**MACEDONIA PLANNING COMMISSION
MEETING AGENDA
FEBRUARY 10, 2025**

MEMORANDUM

Re: Plan Review Comments: 8300 Corporate Parkway – Specialty Lubricants

SUBJECT: Specialty Lubricants Building Addition & Site Improvements

Architectural Canopy Schematic

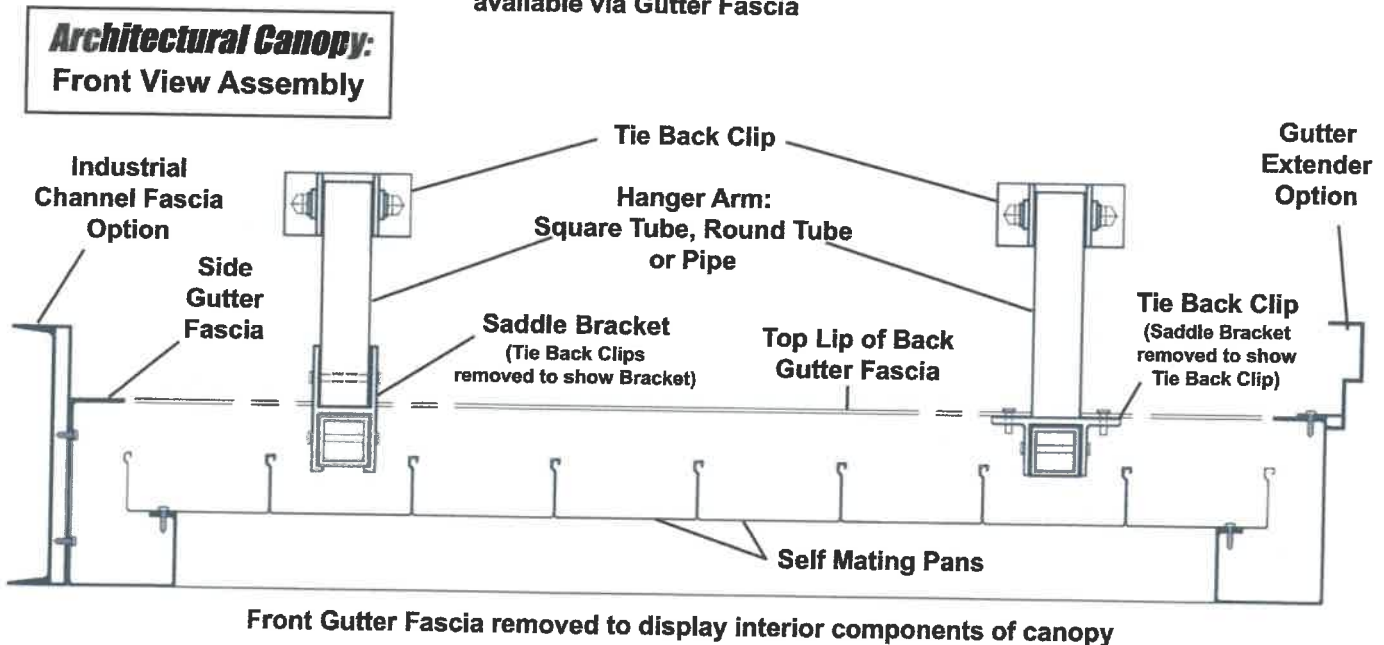
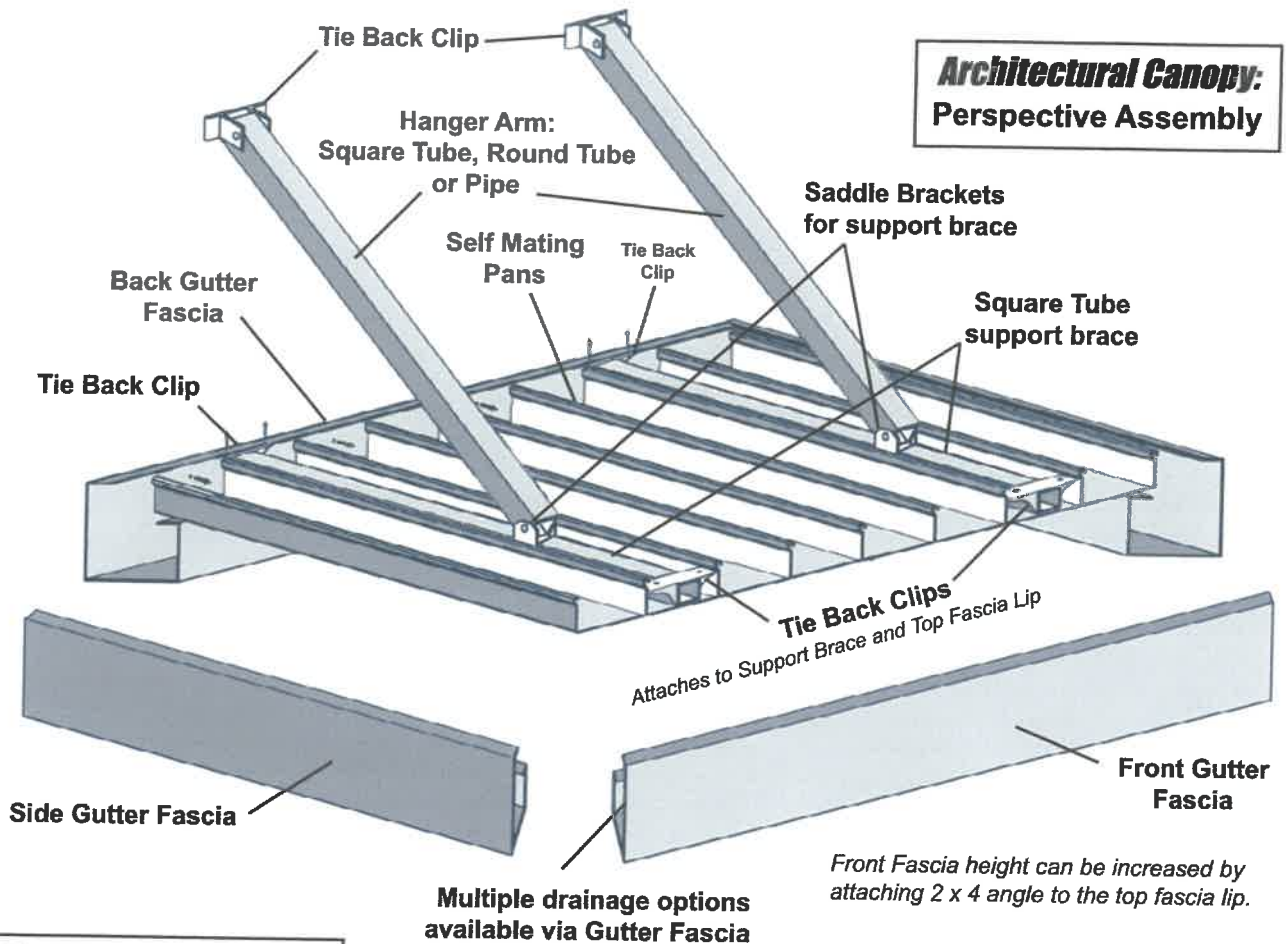
- 4) The applicant revised the black metal awning by securing it to the building, as opposed to using the tubes secured to the ground. This approach is much more aesthetically pleasing, and likely will require less long-term maintenance.

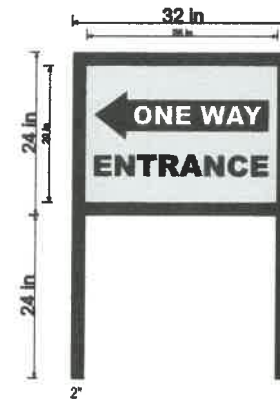
- 3) The 20.98 wall sign adheres to the area limitations of the Code and the applicant has done a nice job changing the materials from the prior printed vinyl graphics to painted aluminum dimensional letters; and

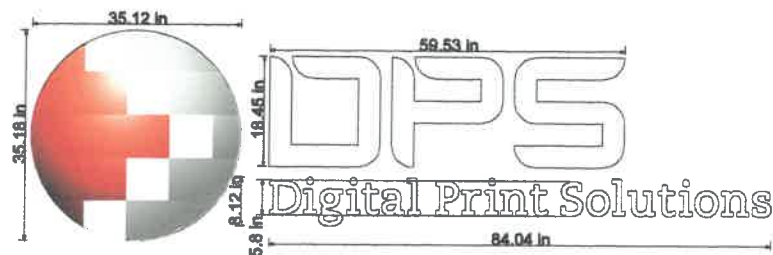
- 2) Section 1179.05 (a) (8) (A-C) provides for instructional signage with certain limitations. The proposed instructional signage does not comply with Section 1179.05 (a) (8) (B) because they are 5.33 square feet (previously 4.45 sq.ft.) and only four is permitted;

The instructional signs are too large and must be reduced to four square feet or less to be exempt from regulation. If the applicant desires to maintain the 5.33 square feet as proposed, then the matter will need to be referred to the Board of Zoning Appeals (BZA) for a variance. The location of the signs must be confirmed on a site plan and the City Engineer should opine about the location relative to the road right-of-way.

NORTH ELEVATION (RIGHT SIDE OF BUILDING)

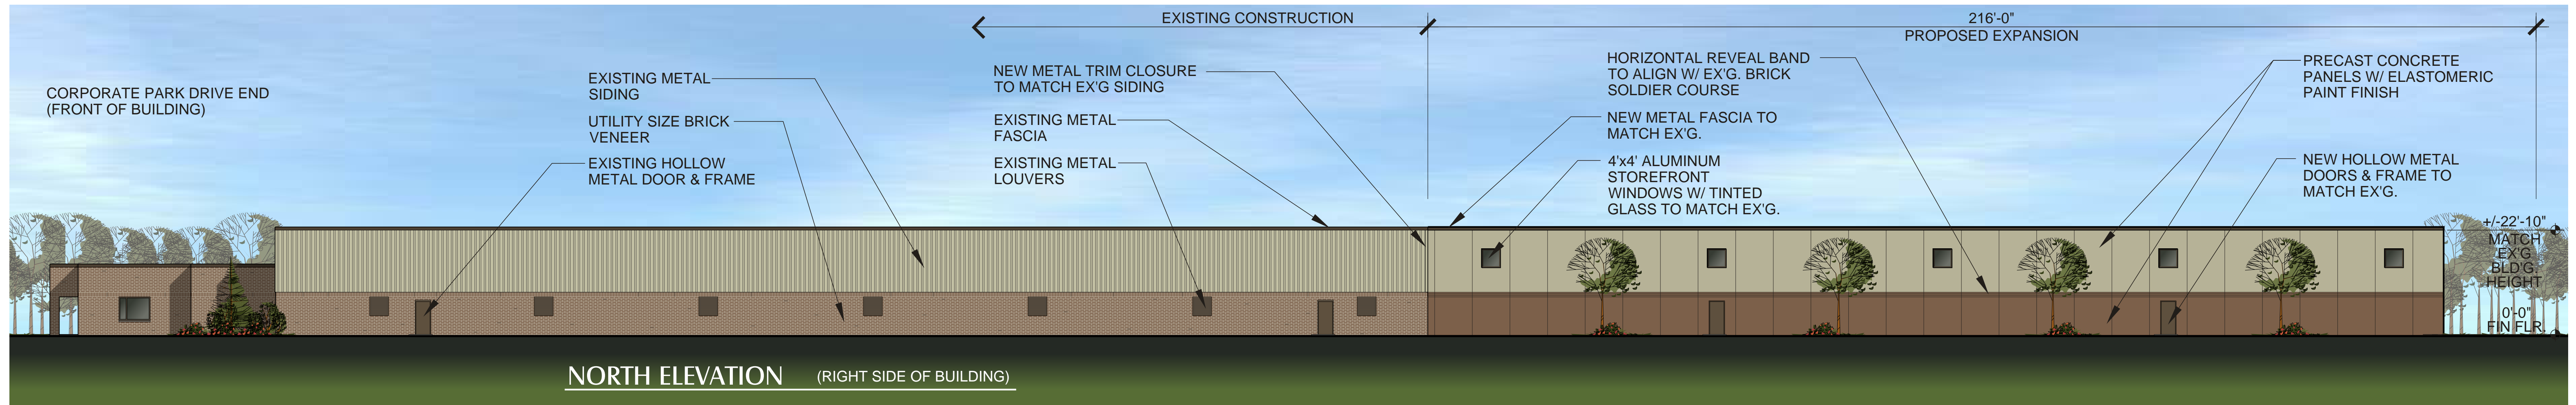
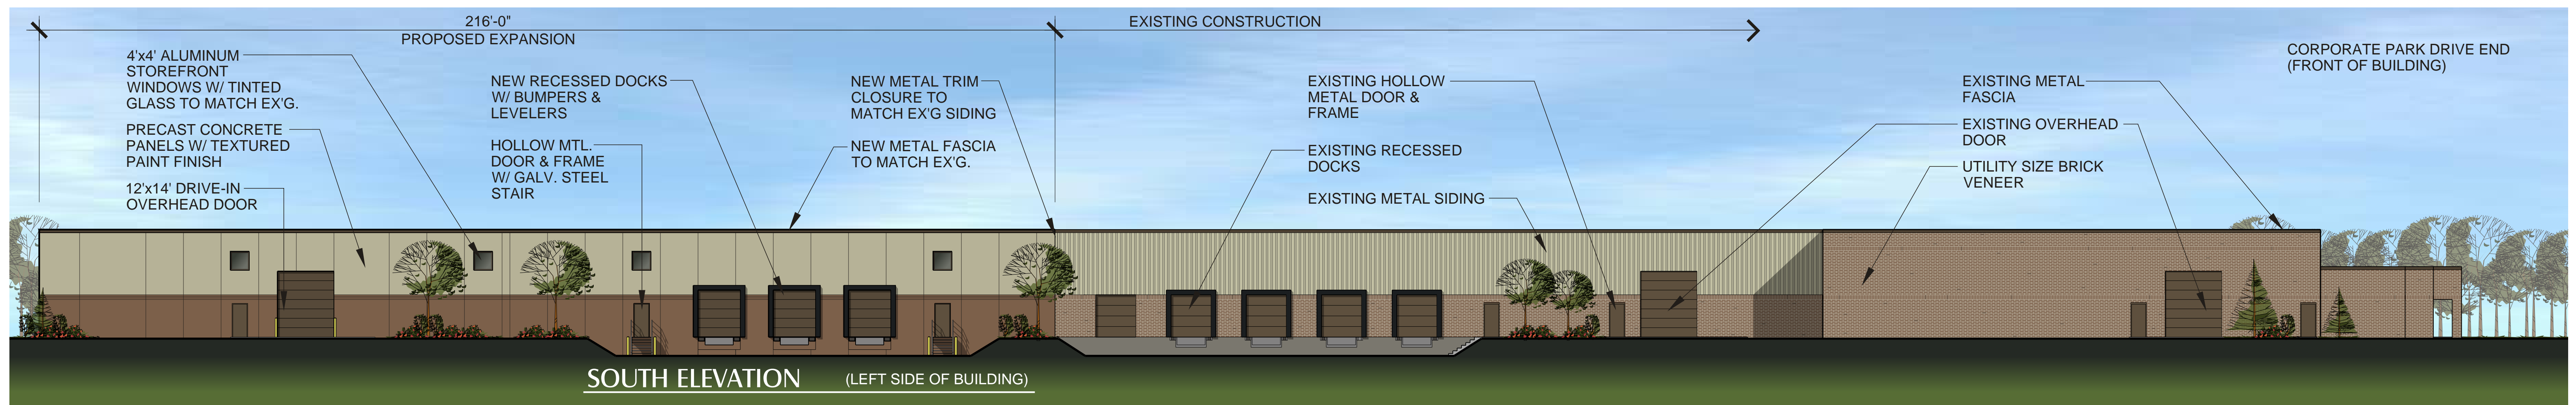
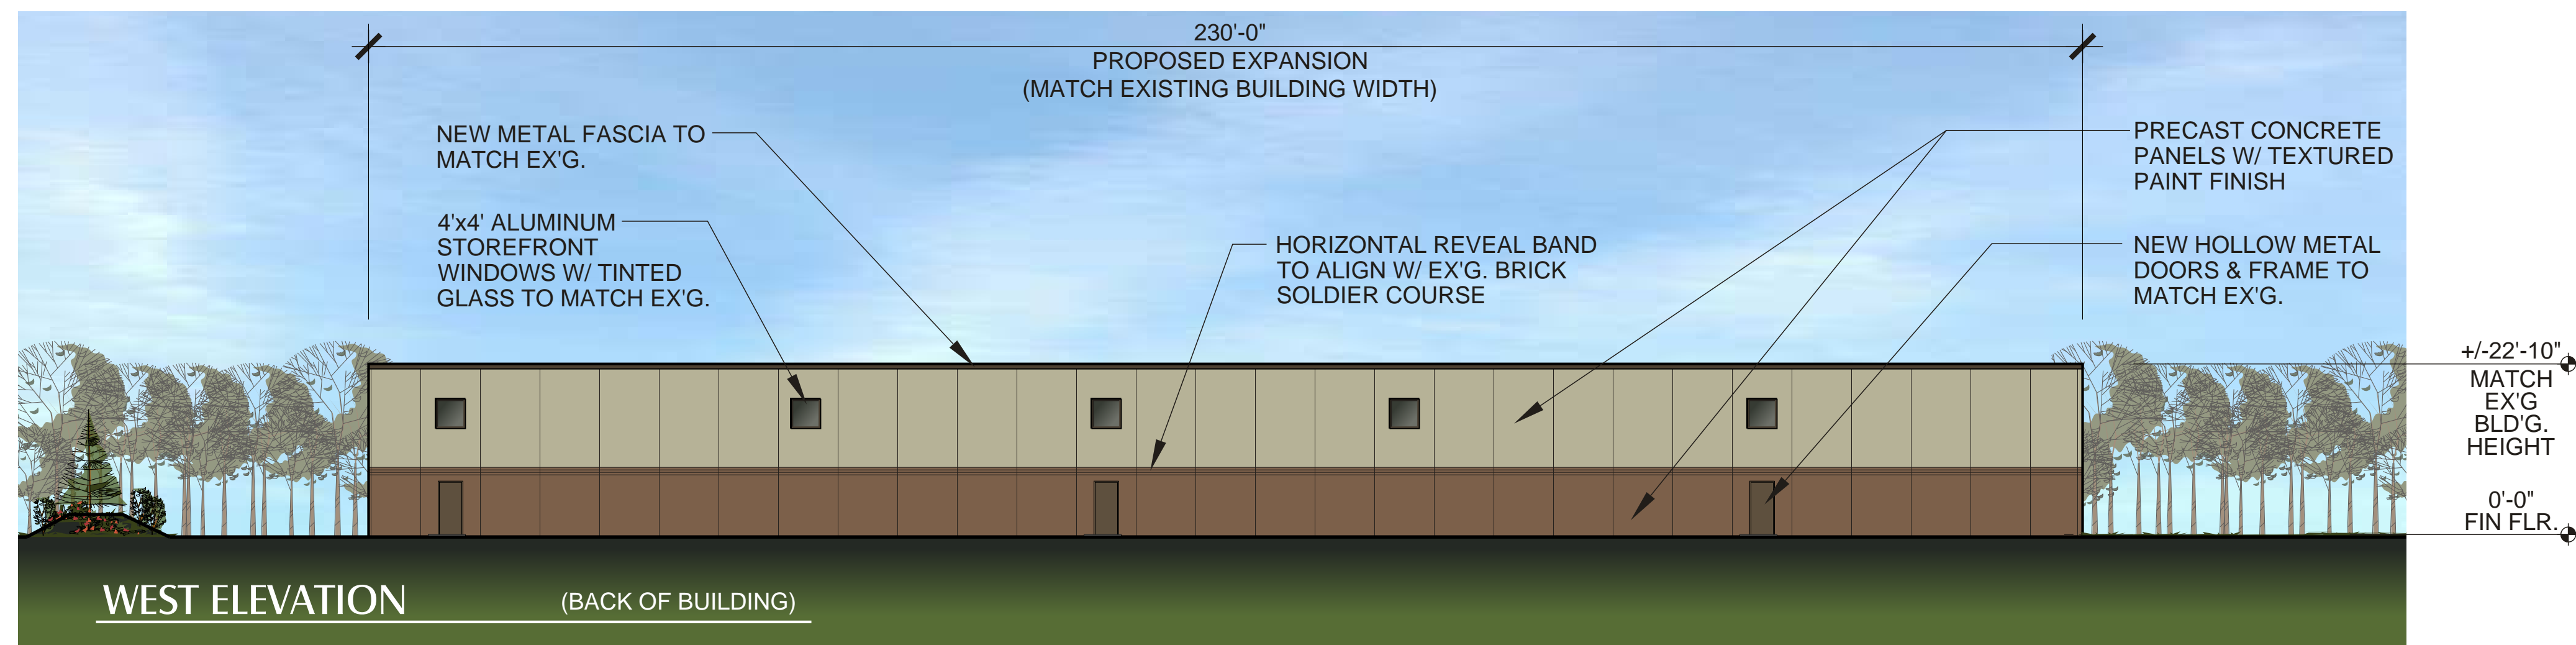
1. The drawings call for the addition to be made from precast concrete wall panels with horizontal reveals. Materials for the addition need to be maintenance free and shall be compatible and harmonious with materials on the existing building. (please see 1172.02(a)(2)(3). The concrete panels being proposed call for "elastomeric paint in a color scheme consistent with the existing facility to maintain visual cohesion." This paint requires more information. My investigation shows this paint requires two coats plus a primer coat and lasts up to 10 years. Re-painting a 50,000 sf addition every 10 years is not realistic. I request investigation into a more maintenance free solution. Is it possible to utilize an aggregate color (with pigments added) that would match the existing building? Creating a panel that matches EITHER the metal siding OR the brick would create a maintenance free building and remain visually pleasing for decades. All materials and colors should be chosen and submitted for review at the time of presenting to the Commission.

3. Details are needed to show the how the new building meets the materials of the existing building. The elevations show the large addition which spans 216' long x 230' wide. Some type of division or vertical material change is needed to separate the existing building from the new proposed addition. This could be accomplished by enlarging the additions' width by 6-8" or decreasing it in size by 6-8". This will visually help with the material changes needed for the new addition as well as providing an expansion joint.

- (8) **Building Architecture** – Sheet SK.2 provides details regarding the existing and proposed architecture. The existing building is clad entirely with brick on the front (the office portion), and the remainder the building contains a brick lower band (~40% of the total) and a metal

siding upper band. The proposed addition is comprised of precast concrete panels painted to match the existing building façade. **ACTION ITEM: The precast concrete panels don't provide a harmonious match with the existing utility brick and metal façade. I understand that the use of the precast panels is faster than typical construction (and often less expensive on new construction), but in this instance the application is difficult to match the existing façade. A possible cost-effective way to tie the two buildings together is to extend the metal panels. Another possibility to match the existing to new is to relocate the windows on the addition lower to match the existing. I believe there is a middle ground to reach as it relates to architecture, but discussion with the Planning Commission is needed.**

DRAWING NUMBER
E-900

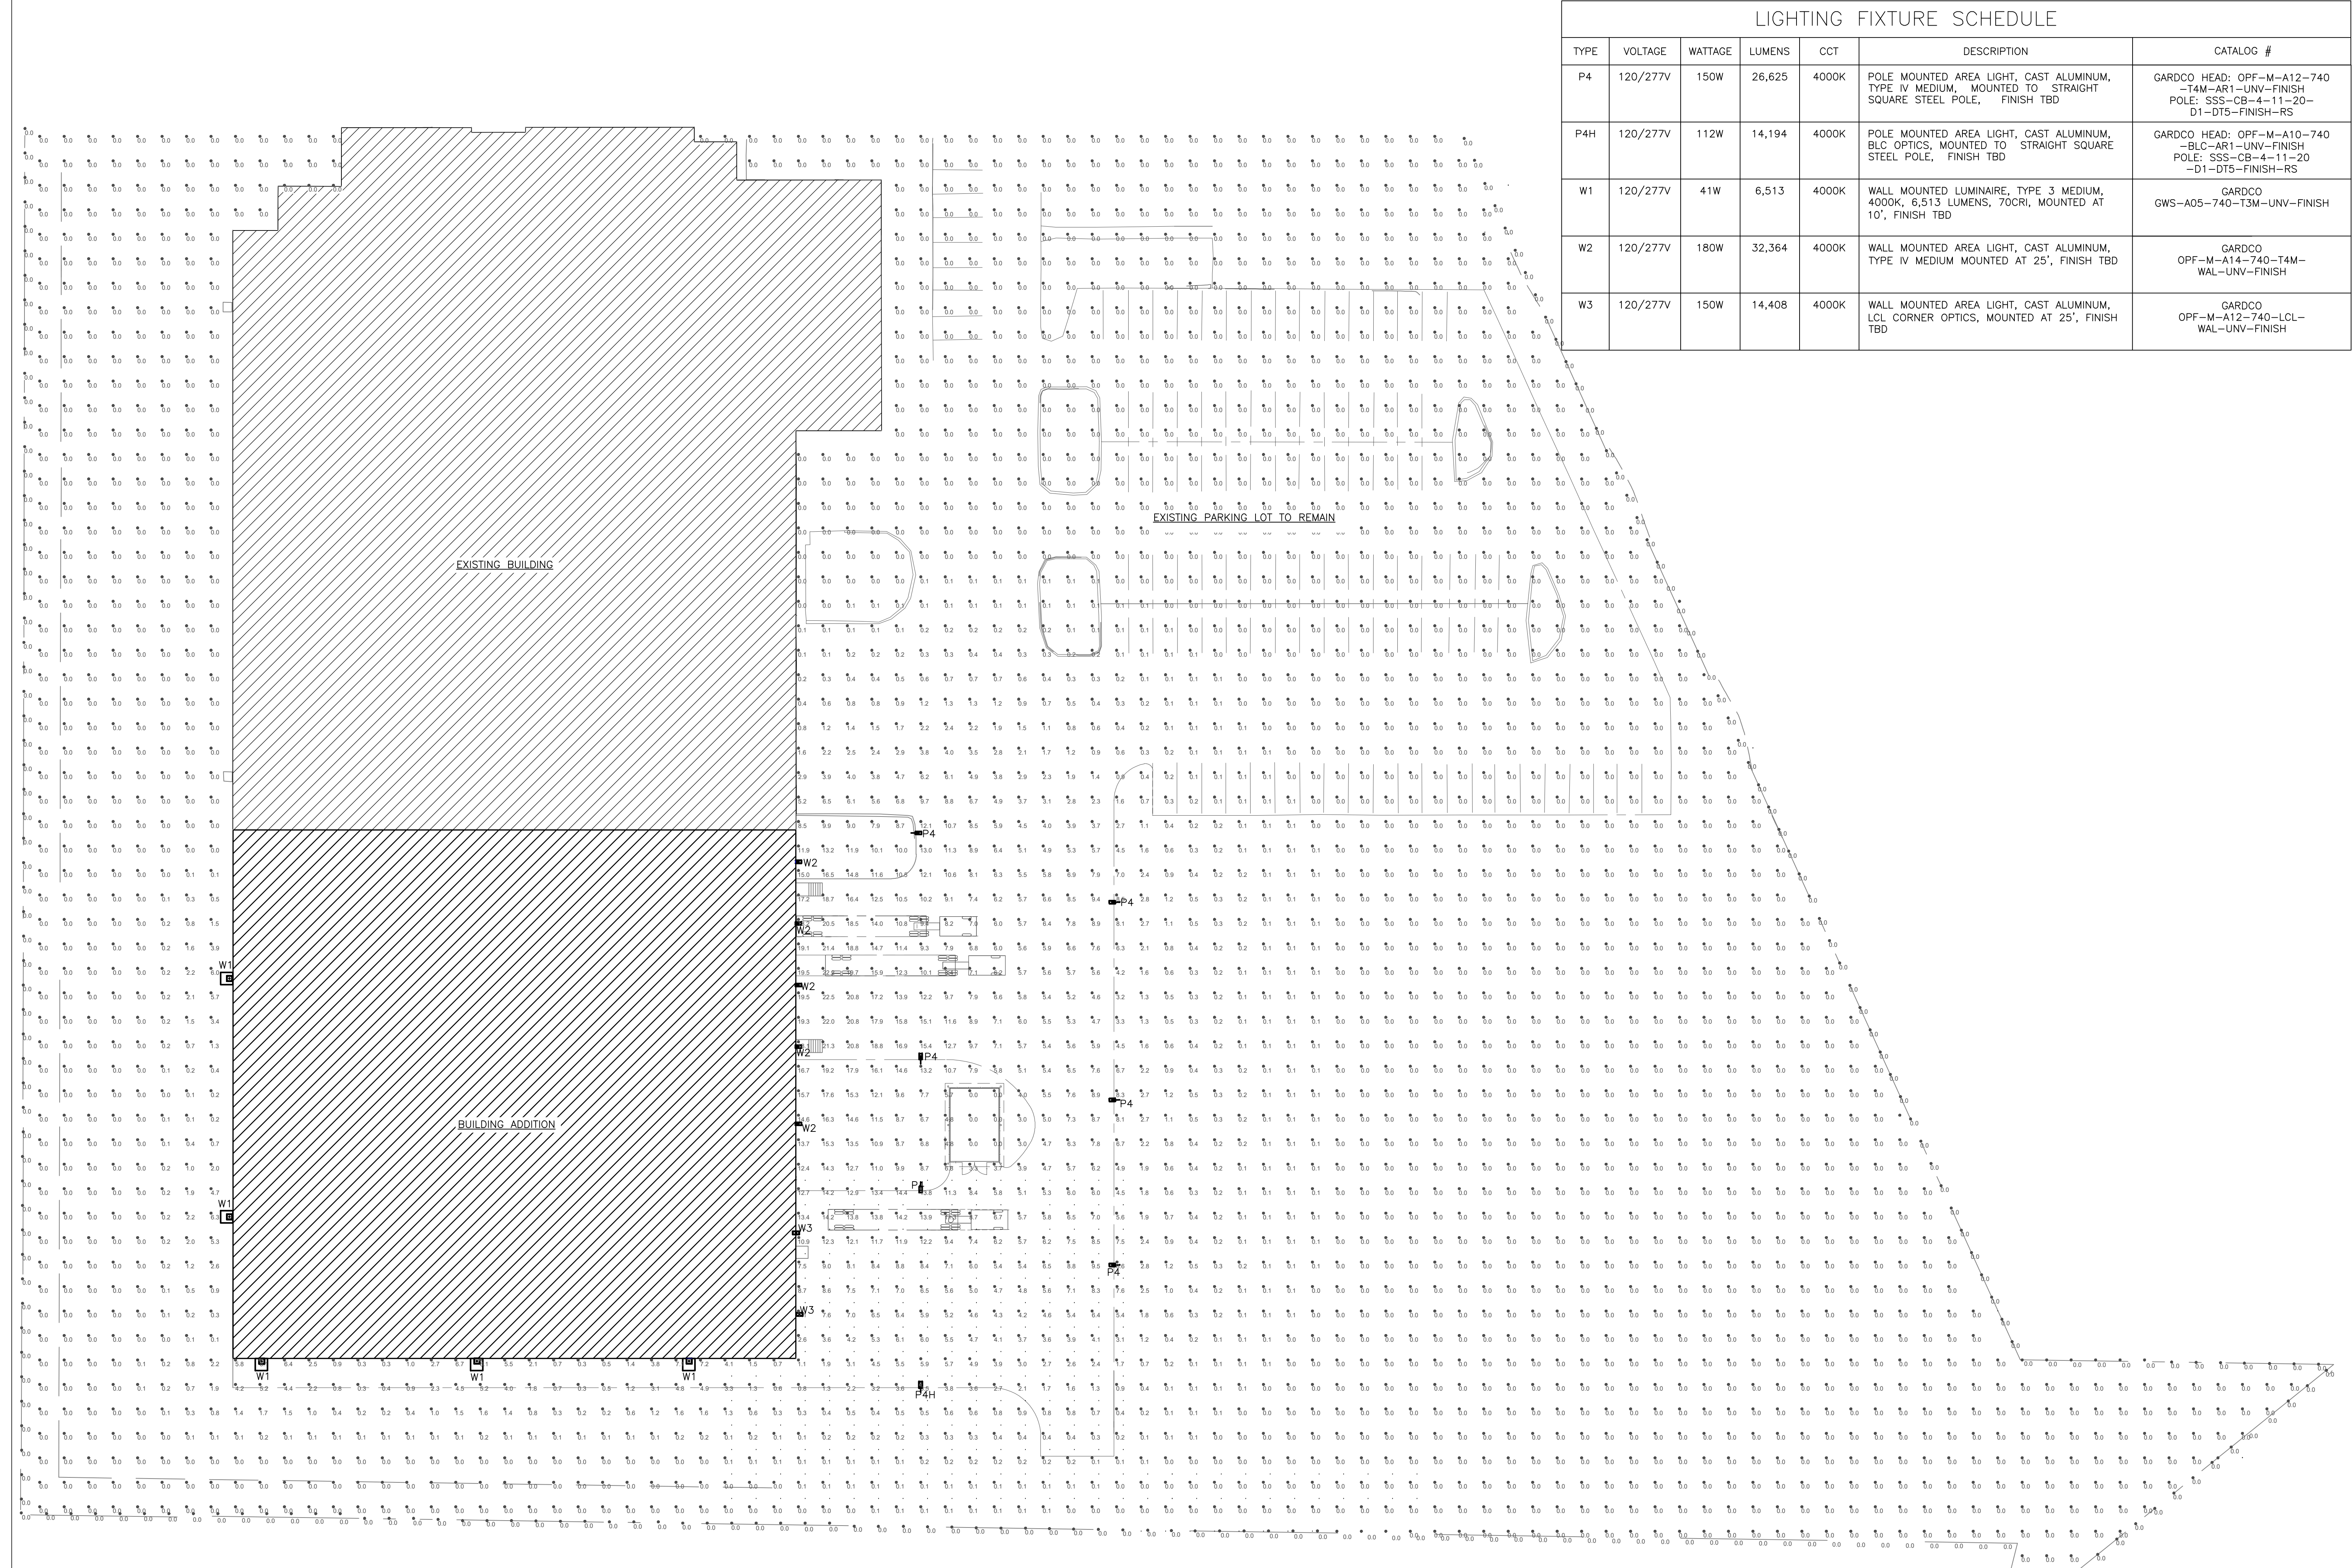
- (6) **Lighting** – Photometrics are included with the submittal on Sheet E-900, but the plan is printed to a scale that is too difficult to read. **ACTION ITEM: The photometrics plan must be provided in a legible format for final site plan approval.**
